## Addendum #02

**PROJECT:** Coit Arts Academy – Phase 2 Summer 2025 Work  
617 Coit Ave NE  
Grand Rapids, MI 49506

**Addendum No.** 02

## Addendum # 2

L-500.2

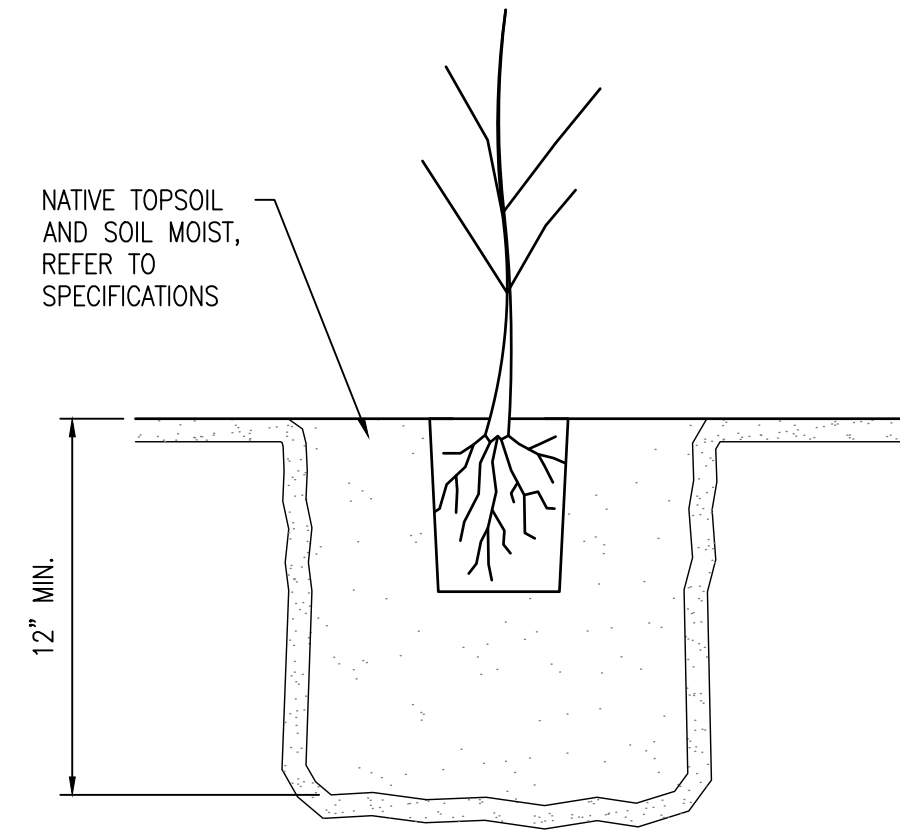
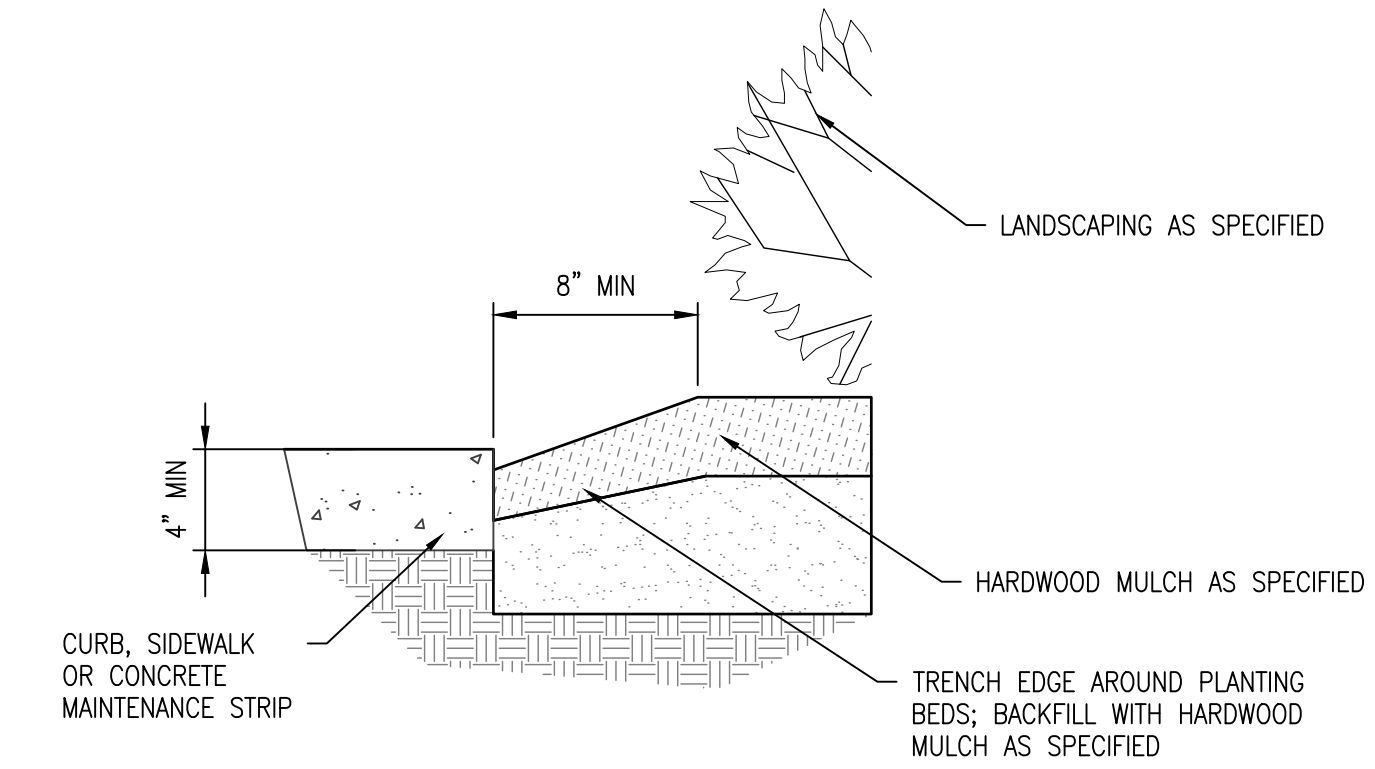
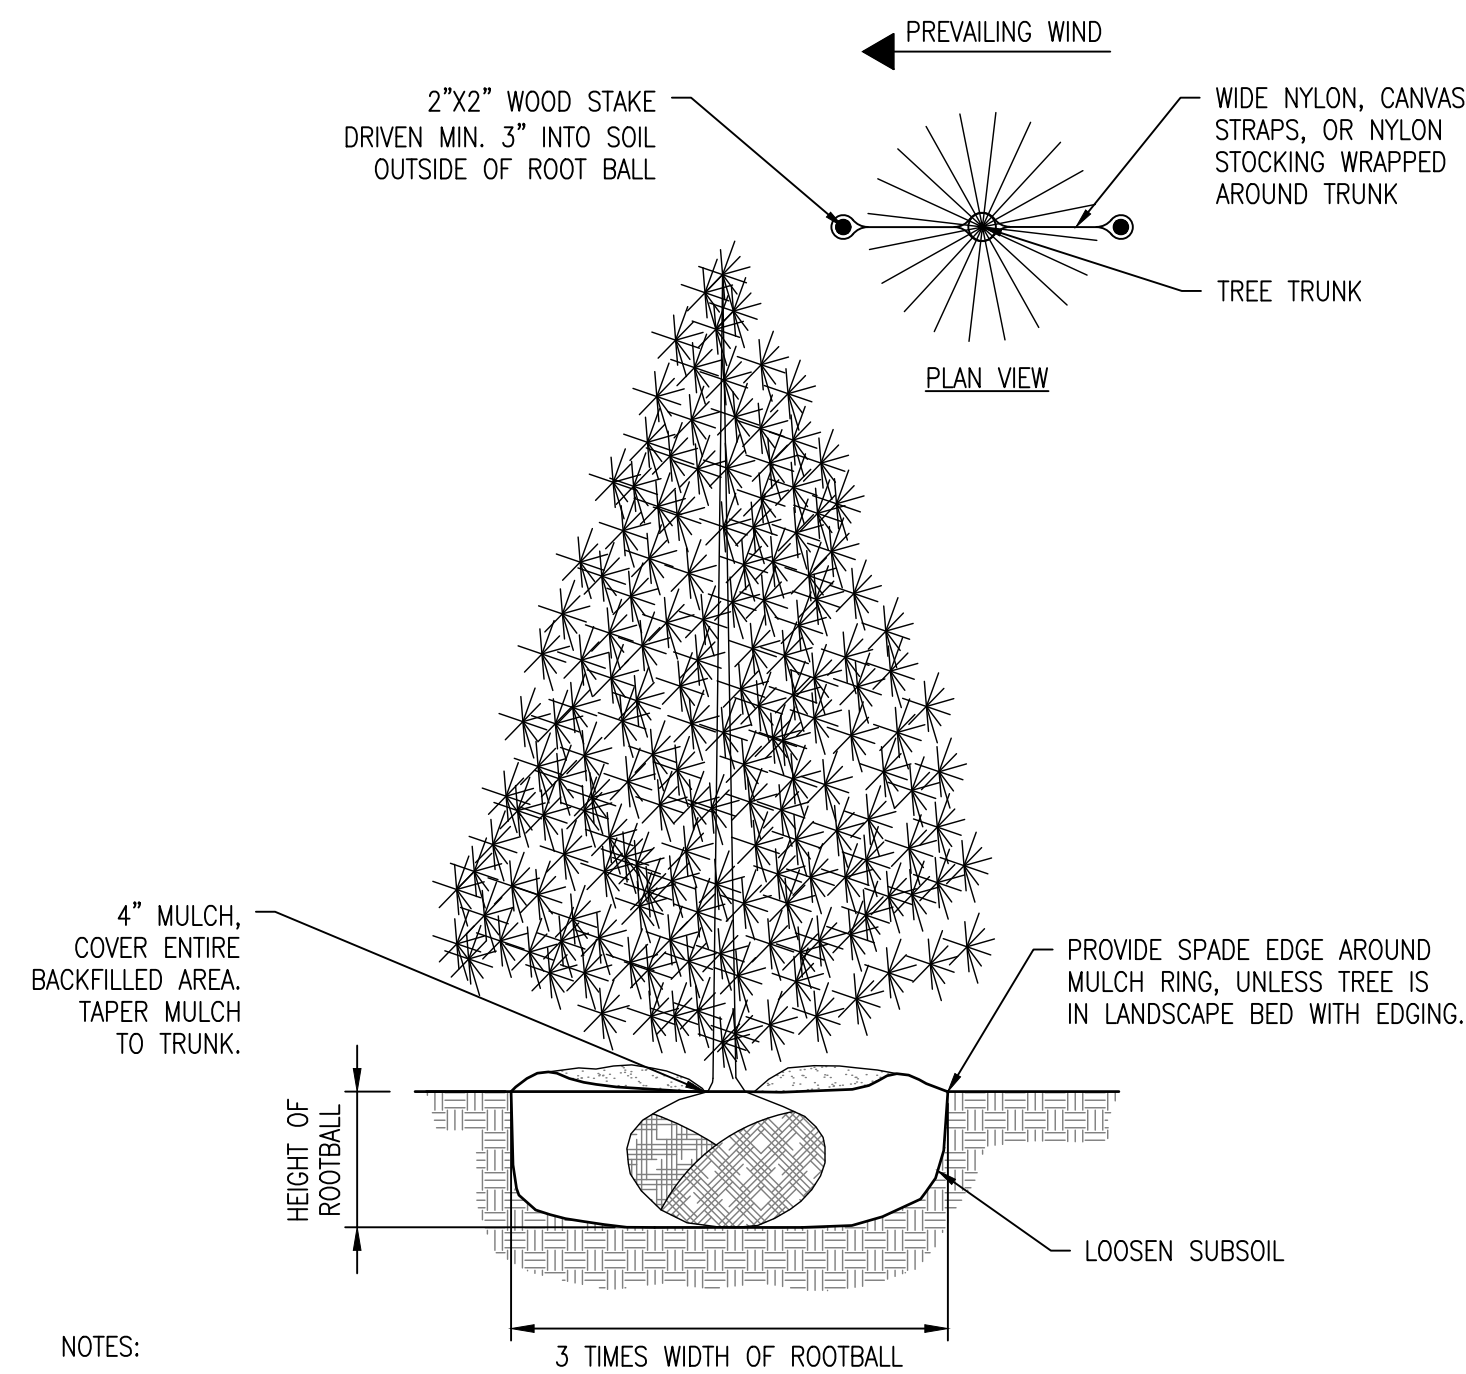
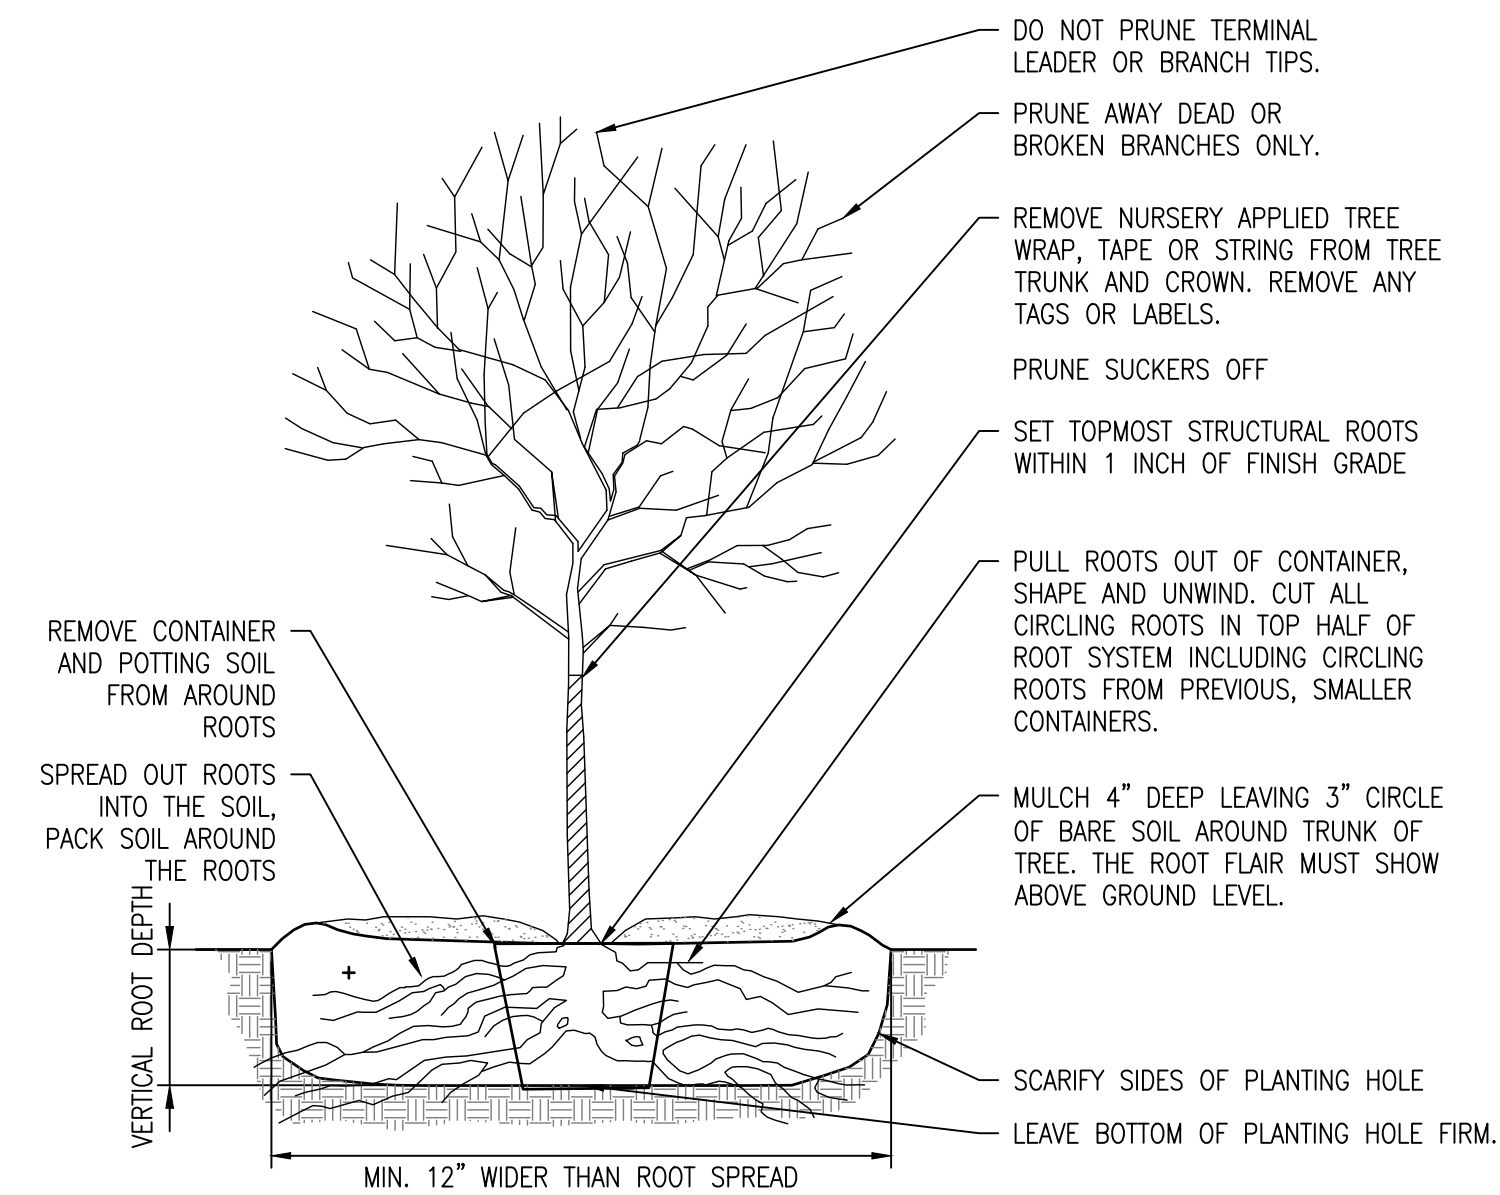
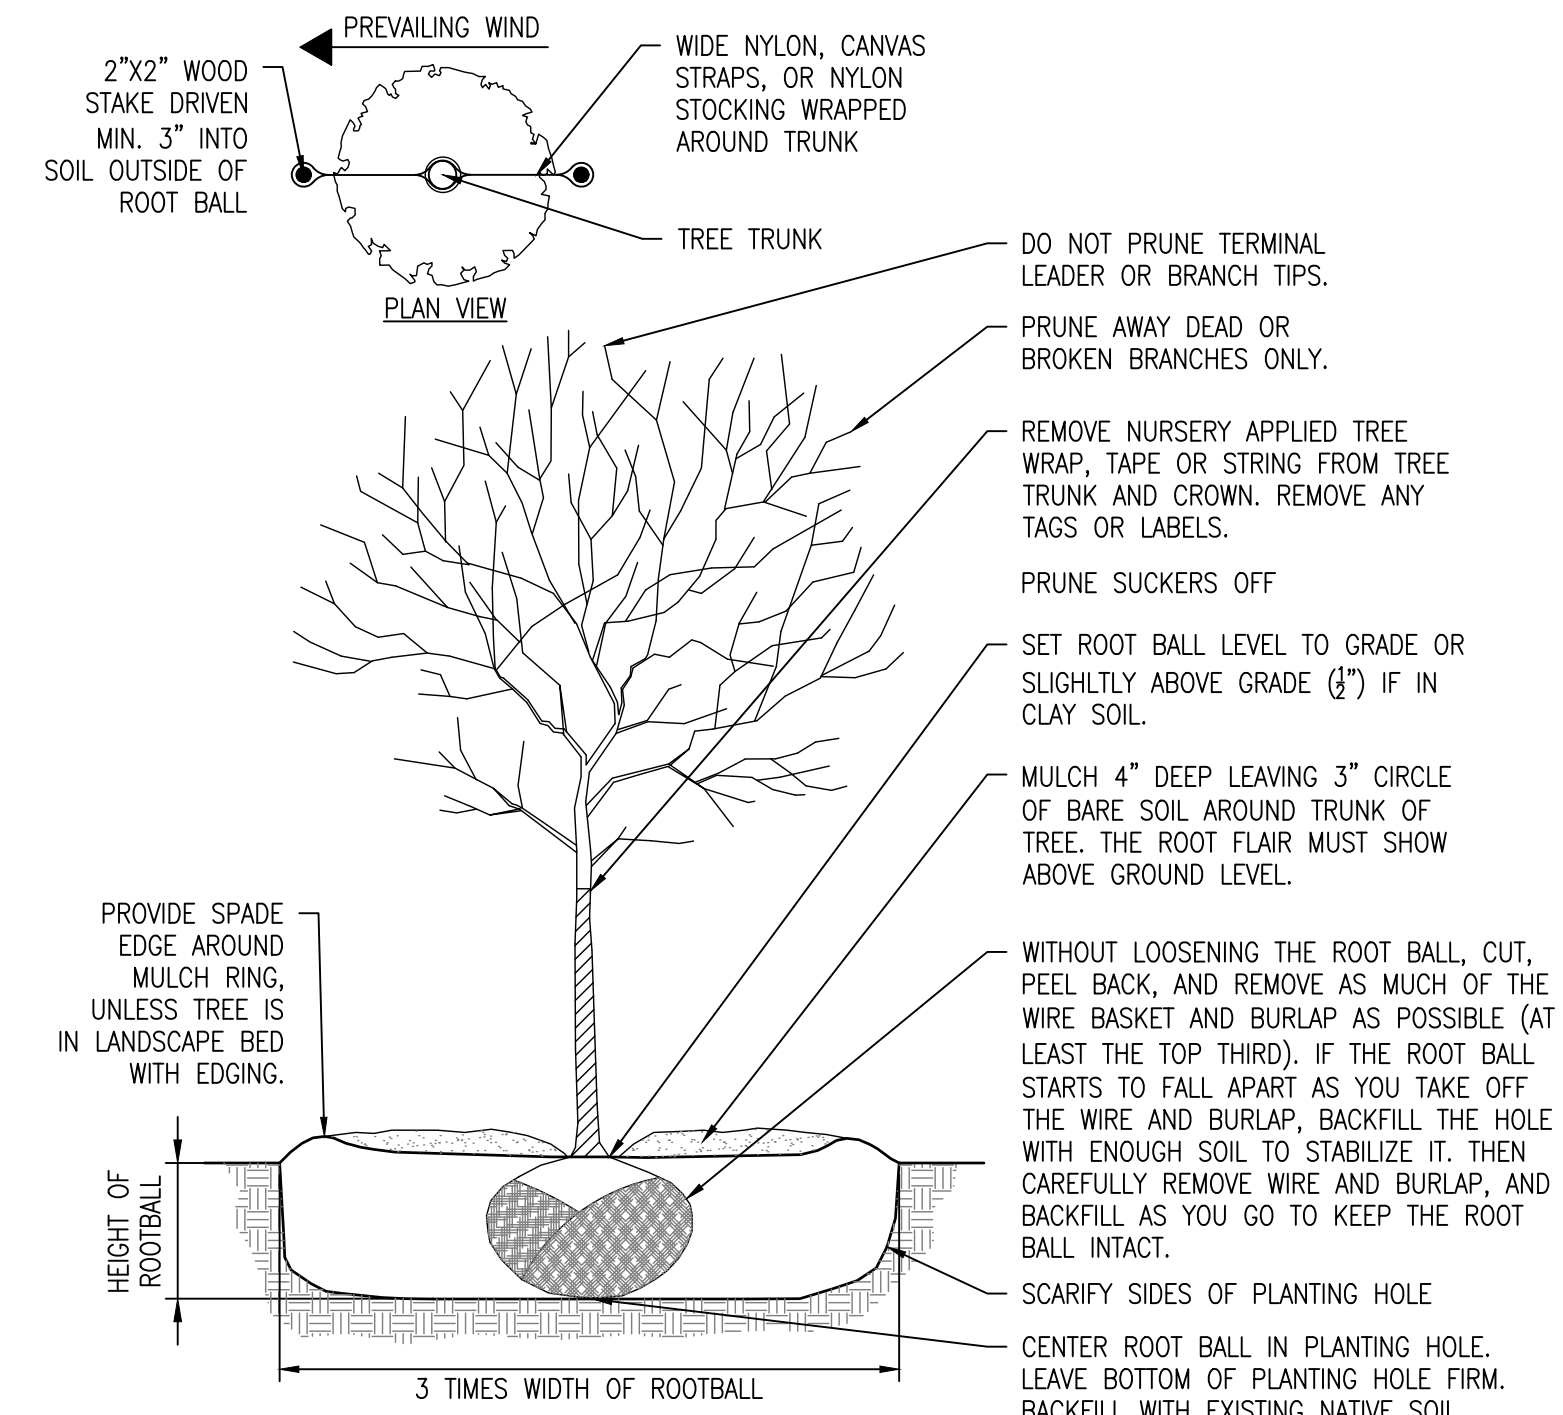
- A2.13 Refer to Sheet L-500.2 (issued):  
Issue new sheet in its entirety. Add details for installation and containment of plants.
- A2.14 Refer to Sheet A-002.2 (reissued):  
Add notes for wall reinforcing and connection to existing structure to the typical masonry partition type details.
